September 10, 2019

TECHNICAL REPORTS REQUIRED Regarding Chevron U. S. A. Inc. [C5640], Cymric Field Cyclic Steam Operations

Exhibit A: Cymric 1Y/36W Surface Expressions

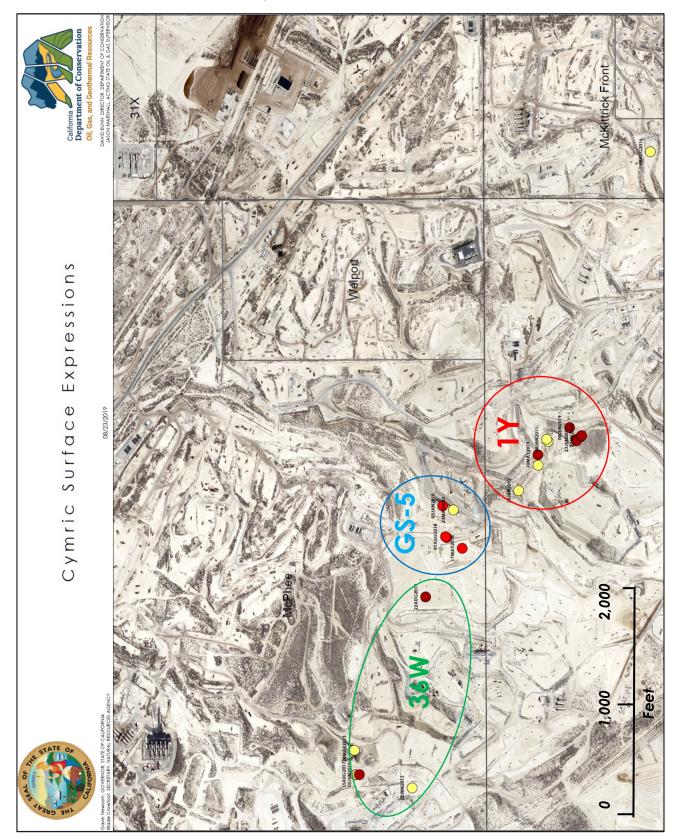
Effective April 01, 2019, DOGGR's revised Underground Injection Control (UIC) regulations prohibit the occurrence of surface expressions. (Cal. Code Regs., tit. 14, (CCR) § 1724.11, subd. (a).) Chevron is the operator of approximately 350 active cyclic steam injection wells in the Cymric field, and since April 1, 2019, there have been at least eight surface expressions intermittently or continuously active within the Cymric field within three areas that DOGGR has identified as: 1Y, 36W, and GS-5. The delineation of these areas and the location of the surface expressions are detailed in the attached map (Exhibit A).
